### **AEMO Rule Change Application - Generator Technical Performance Standards**

I refer to the AEMC's current consultation on the Rule Change application made by the Australian Energy Market Operator.

**Figure 5 Proposed system standard for power frequency over voltage**

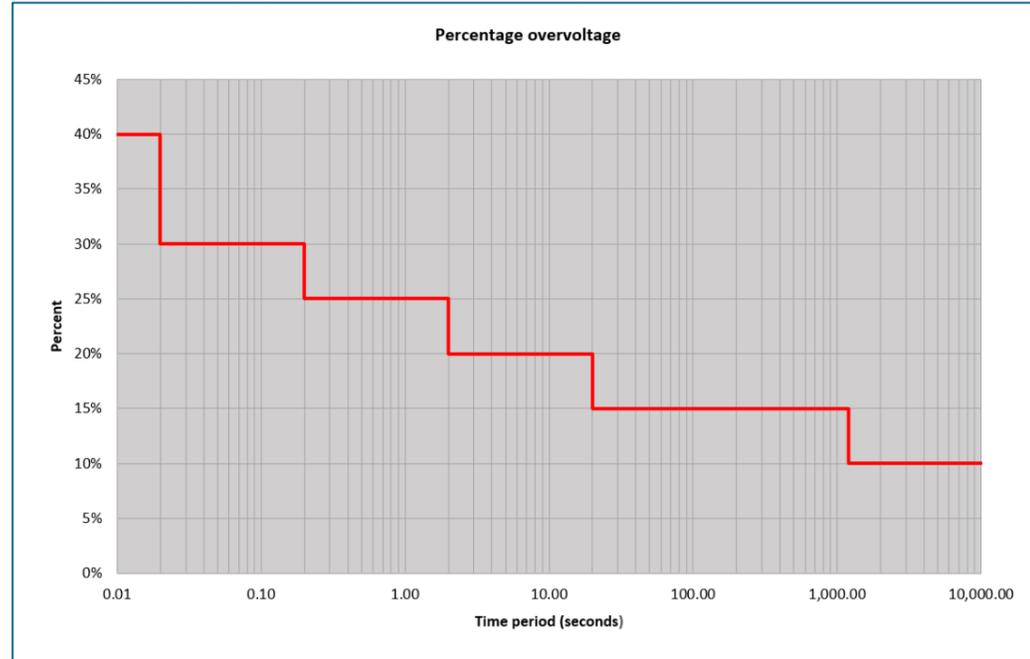
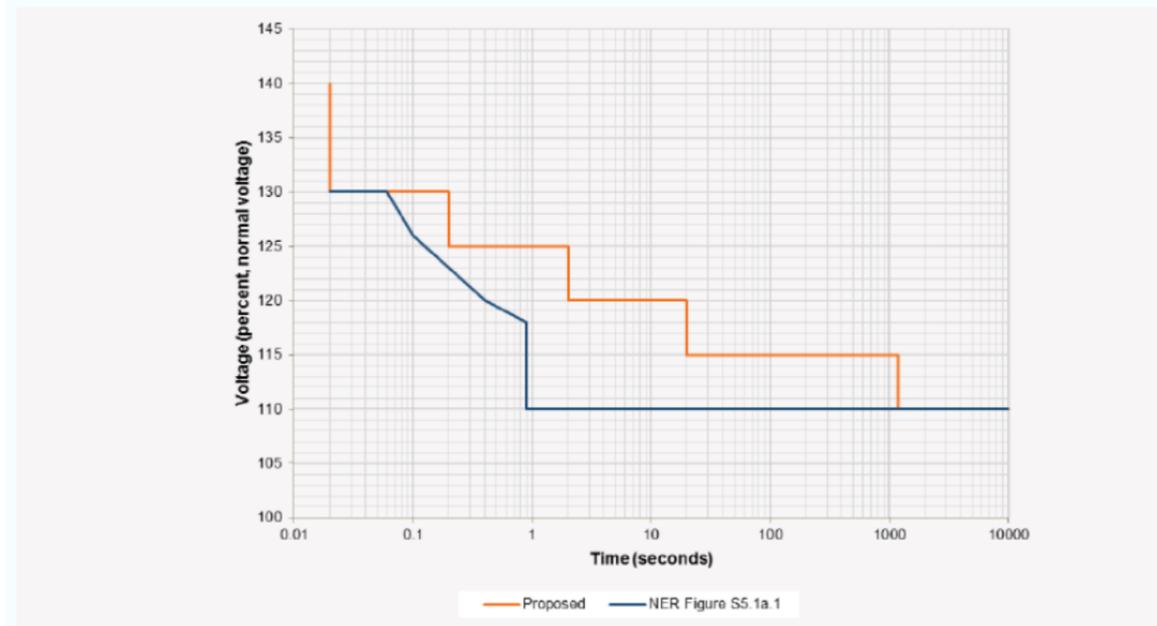
[The only changes proposed by AEMO are to replace Figure S5.1a.1. with the following]

These requirements appear to be very onerous and many generators currently connected to the system will not be able to meet these over voltage levels without sustaining damage or significant loss of life for insulation componentry.

AEMO have not provided any justification above the 115% level (which is currently the highest power frequency overvoltage allowed) and do not appear to have investigated what the possible impact of this change is on new and existing generation plant.

Whilst new generation plant can be built to comply, this would result in an over investment in electrical insulation and voltage rating of equipment.

Existing plant, in particular synchronous and asynchronous generators, transformers, capacitor banks, cables, power electronics and other electrical components would be at risk of significant damage if exposed to high over voltages for the time periods being proposed.

Pacific Hydro recommends that this change to the TOV be rejected as this significant change to the transient over voltage “ride through” requirement appears to fail to consider the existing plant that is unlikely to operate through such over voltages. Many existing power electronic devices cannot sustain this level of voltage and protect themselves from it.

There does not appear to be sufficient technical justification provided in the rule change proposal. The events that have occurred should be examined to see whether the NSP has planned the network requirements and whether there is a need for a broad network solution to the temporary over voltages that have occurred.
